DPEMP SUPPLEMENT

'THE GUMS' QUARRY, PALANA ROAD WHITEMARK, FLINDERS ISLAND

The Environment Protection Authority (EPA) received additional comments from referral agencies in relation to planning application DA 012/216 and supporting documentation including the document entitled *Development Proposal and Environmental Management Plan, ‘The Gums’ Quarry, Palana Road, Whitemark, Flinders Island* dated 9 October 2016 (DPEMP).

Existing sediment pond from previous operations of the quarry.

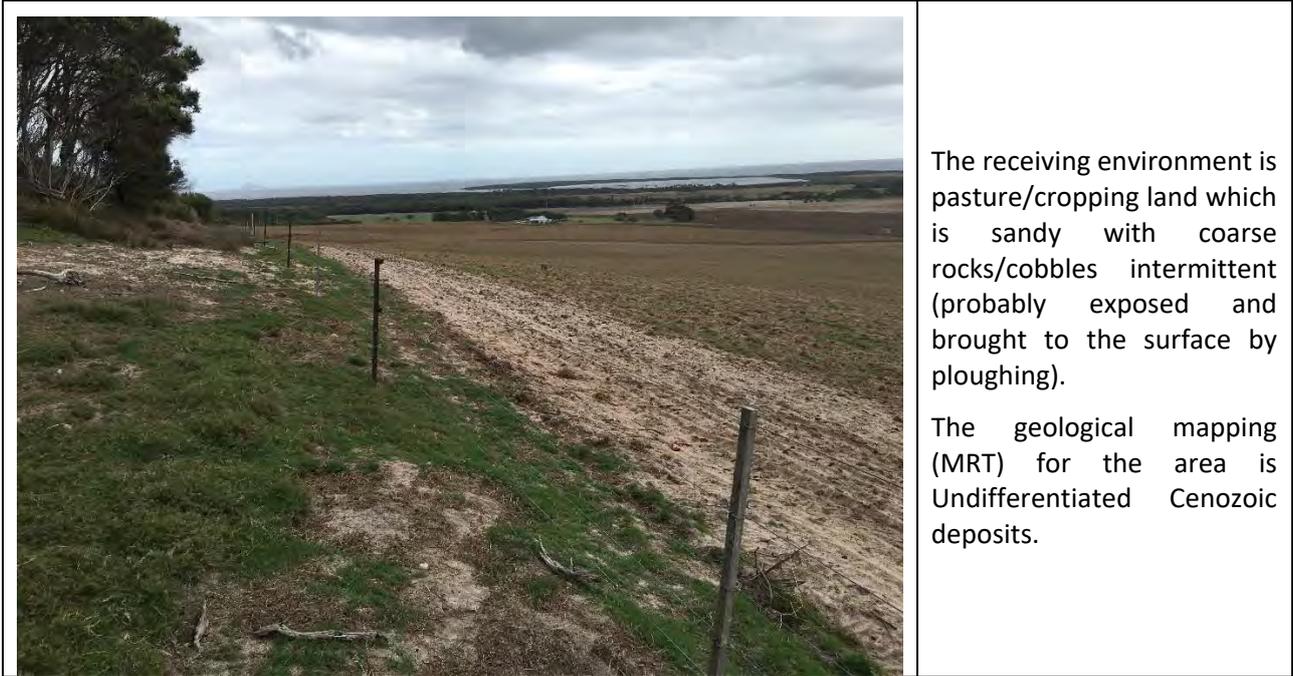
Provide a description of the current condition of the receiving environment for runoff from the site, including any degradation apparent as a result of historical operations on the quarry site. Discuss any changes to runoff volume and quality likely as a result of the proposal and the potential impacts.

Note that the current water/sediment control measures are virtually dysfunctional and water has therefore been flowing freely into the receiving environment with little sediment control. Logically, the installation of such a system that is appropriately sized and located would serve to improve this situation.

Images below show the sediment pond arrangements as they currently occur and the receiving environment.

The 'pond' is sediment-laden and being colonised by sheoak (*Allocasuarina verticillata*). The quantity and age of the seedlings of this species is suggestive that the pond has not been cleaned (to maintain water holding/sediment removal efficacy) for many years.

11 June 2013 – Google Earth Image

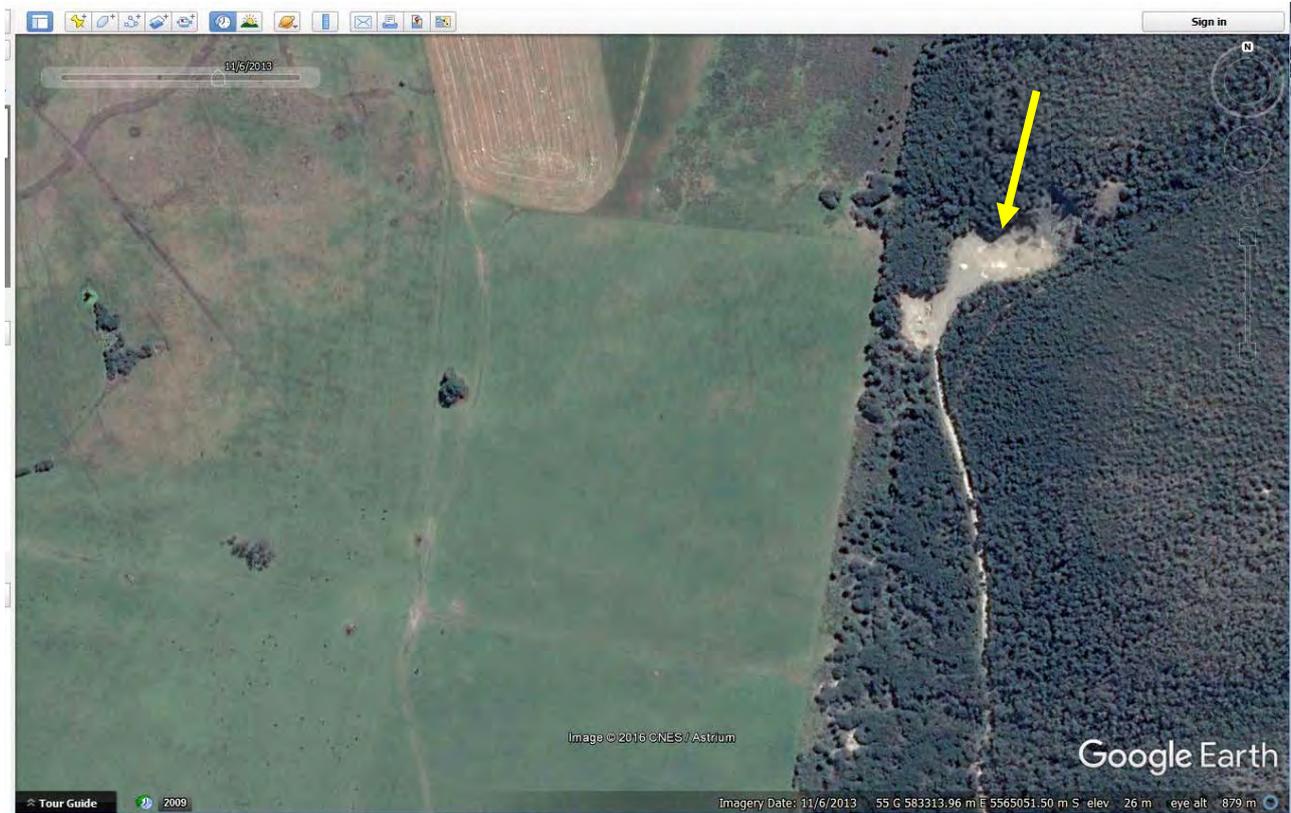
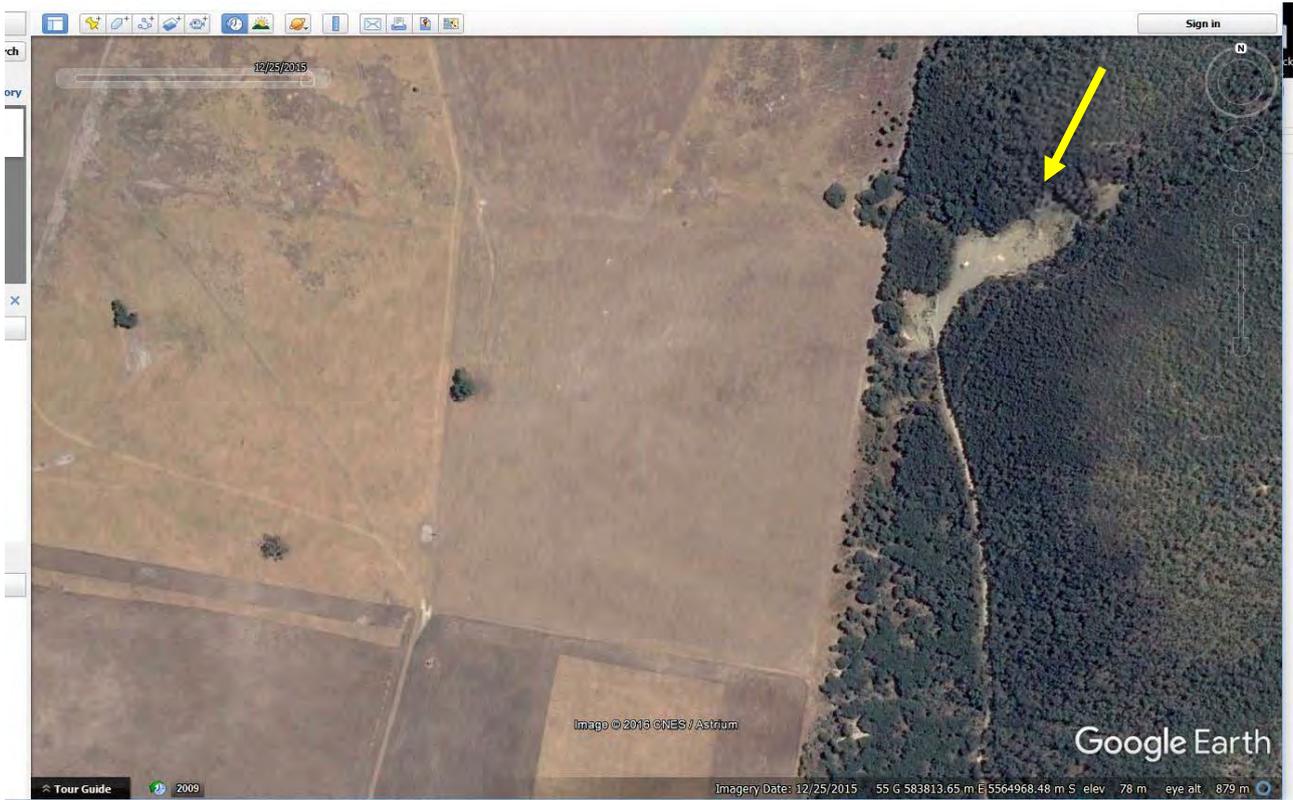
The blast management plan in the DPEMP must be amended to ensure neighbouring agricultural land is identified as a receiving environment and mitigation measure should be provided to specifically manage potential deposition of flyrock on that land. The potential location and facing of initial blasts is necessary information to enable assessment of potential flyrock deposition on the neighbouring agricultural land without mitigation.

The images below show the location of the quarry as a yellow arrow relative to the adjacent agricultural land.

If these paddocks became ‘full of fly rock’ by previous operator’s poor use of the quarry 13 years ago then it was at that time the landowner of the adjacent agricultural land should have acted to correct the mistake – their failure to act about an alleged fly-rock incident cannot be used now as a justification to prevent an activity from occurring.

**THE GUMS QUARRY - WHITEMARK
 DP&EMP SUPPLEMENT
 FIGURE S-1A: PROPOSED ACCESS ROUTE AND STOCKPILES
 FOR MAJOR PROJECTS AT THE GUMS QUARRY**

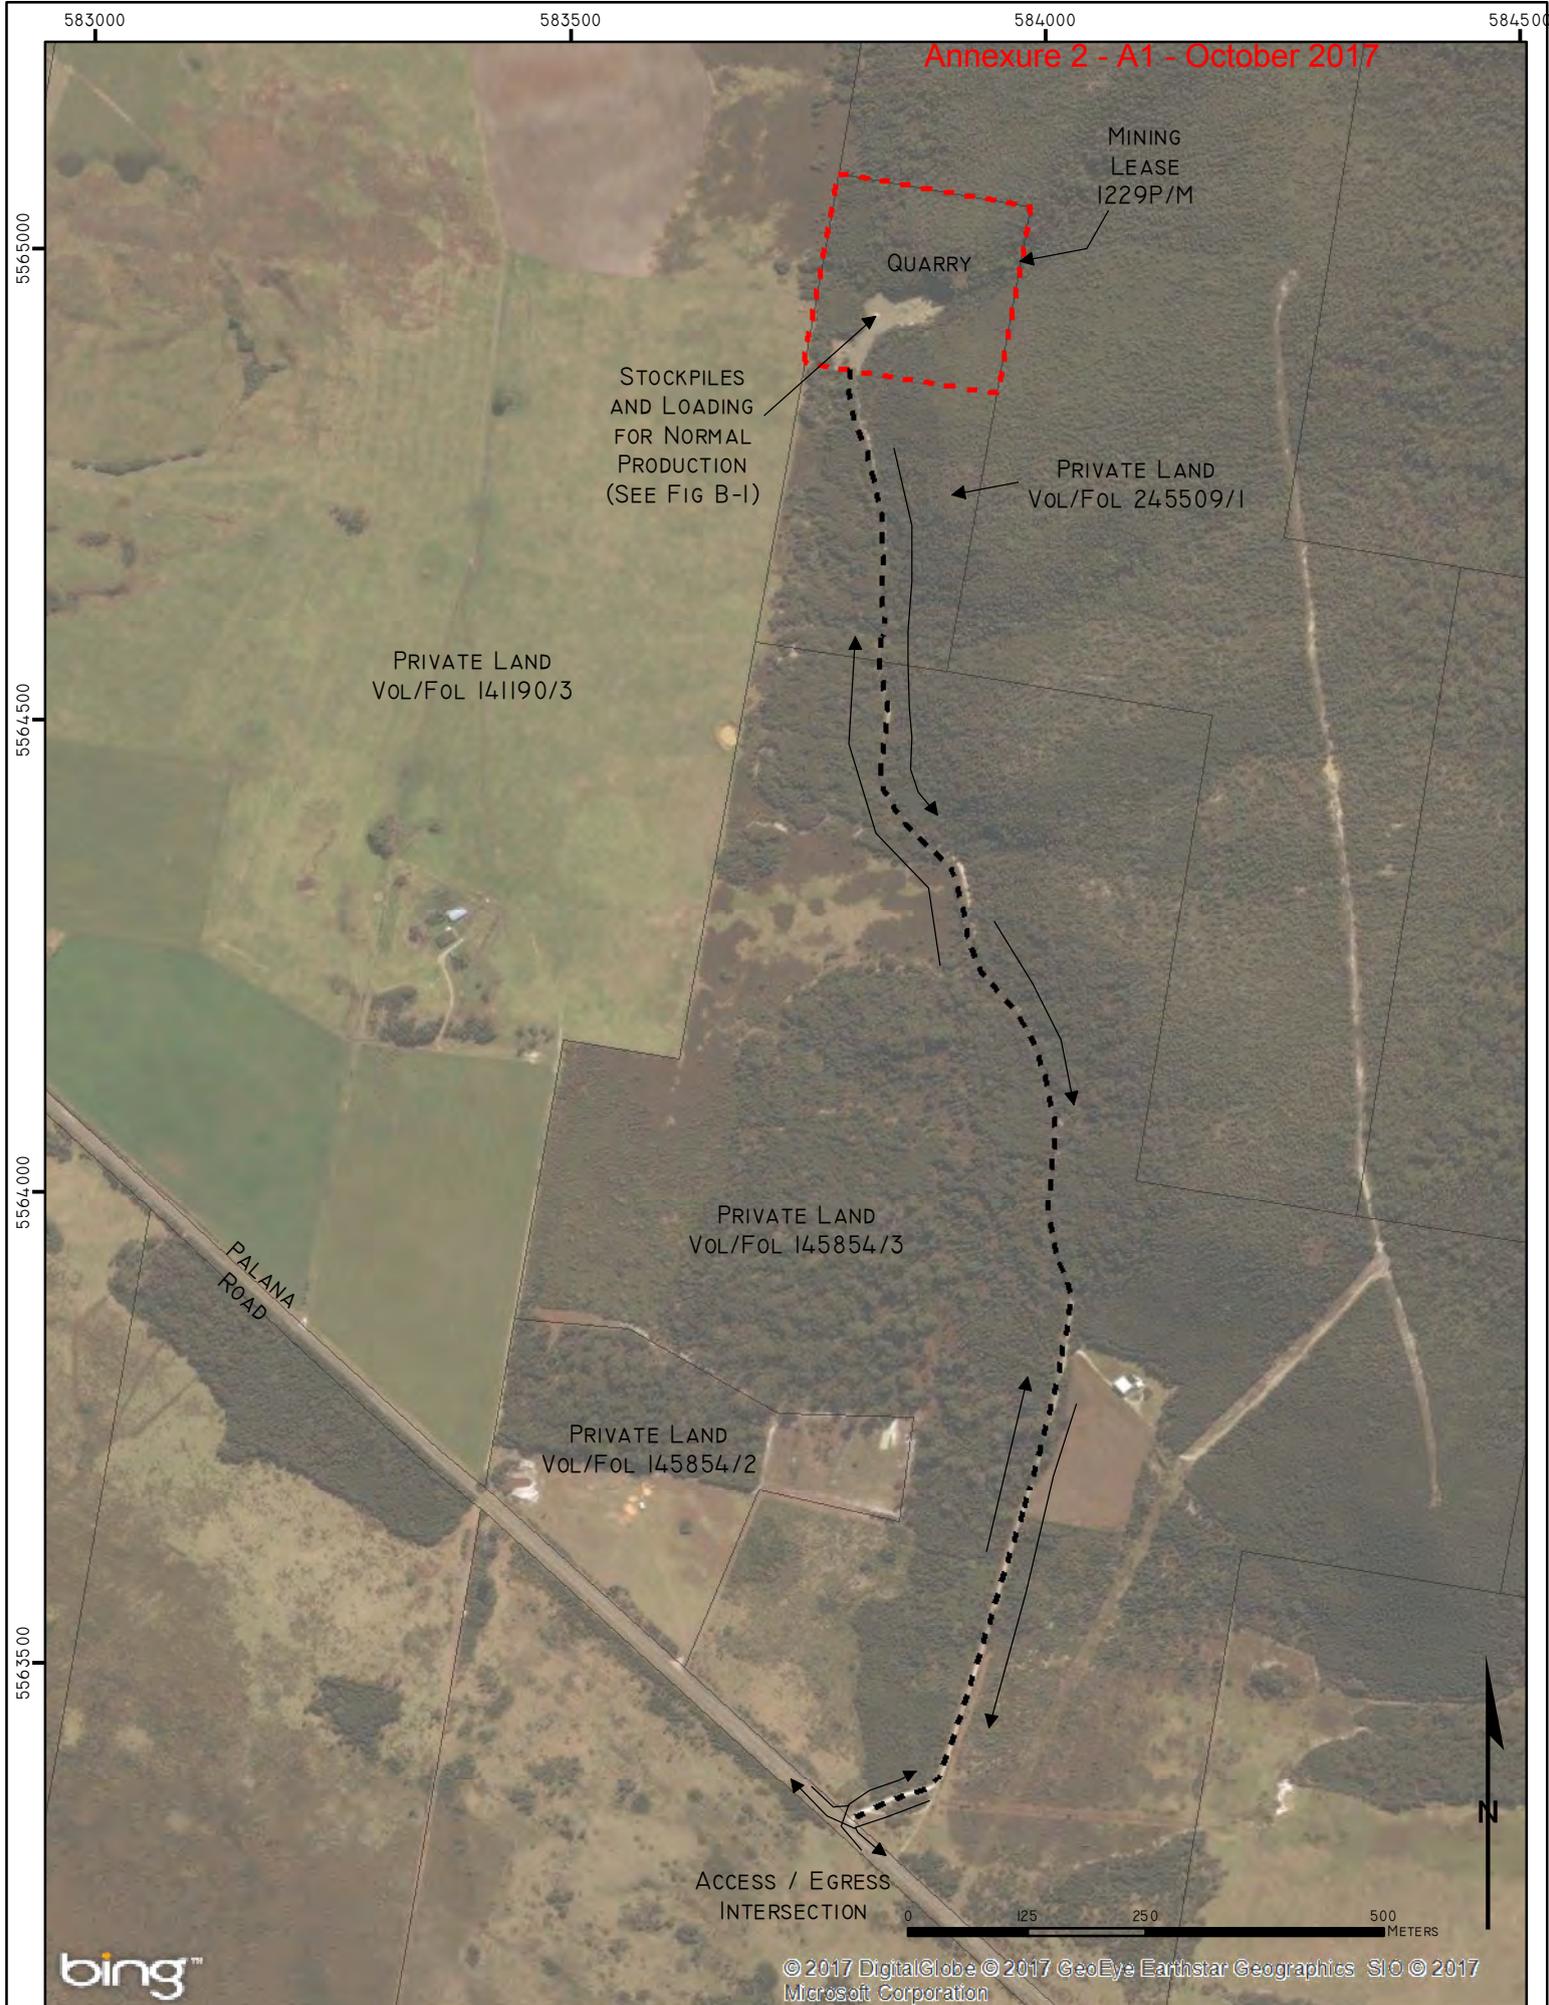
| <p>Confirm the access routes from Palana Road to the quarry site and provide the map grid coordinates of each access point to the land to which the planning application relates, noting that these access points may be relevant to the EPA Board’s determinations.</p> |
| <p>If the existing access road on the land is to be used then provide details of distances of the road from residences and any other sensitive receptors, noting whether these residences are in ownership other than by the owner of the land to which the application relates.</p> <p>Discuss potential noise impacts associated with the use of this route as opposed to the route detailed in the DPEMP.</p> |
| <p>If a change in traffic movements is proposed, confirm all potential routes for inbound and outbound traffic, volumes of traffic on each and circumstances under which they are to be used.</p> |
| <p>It is noted that there is an existing alternative access route to the proposed quarry on the application land. It is also noted that Council have advised that the use of the existing access road, at least for some vehicle movements, is being considered. As discussed above confirmation of vehicle route usage is required.</p> <p>Submit a dust management plan which takes into account road routes on the land to which the planning application for the proposal relates. The plan should include:</p> <ul style="list-style-type: none"> • an assessment of the potential dust generated from the road surfaces and from the quarry location to cause an environmental nuisance at the nearest residence in other ownership. This assessment should be based on available meteorological data and take into account worst case weather conditions. Mitigating factors such as distance of the routes from potential residences in other ownership and vegetation screening for each route should be taken into account. • Procedures for dust monitoring and complaints response • Practical mitigation procedures eg circumstances under which work will be ceased to allow for surface wetting or for unfavourable condition to dissipate. <p>It is noted that although the EPA Board is not requiring that the dust management procedures be applied to that part of the proposed access route located off the land to which the planning application relates. It will consider such impacts directly attributable to the proposal in its decision making regarding the proposed activity. Particularly where a viable alternative route which may pose less of a potential risk is available.</p> |

The grid coordinates (GDA94 datum) for the access ways into the **Land** are shown in Figure S-1a. This includes the Right of Way and the main access into the land.

1. **Major Projects** – A loop will be established as shown in Figure S1a for trucks to enter the ROW to access stockpiled material on 634 Palana Road which will then exit via the existing access to 634 Palana Road. The SISD distances required by the Scheme for both the ROW and existing access are met. Trucks will cart material from the quarry to the stockpile location, but these will be separate to the trucks collecting and delivering the material. The process of trucks entering the ROW and exiting via the existing access is depicted in Figure S1a; and
2. **Normal Production** – the existing access will be used as depicted in Figure S1b.
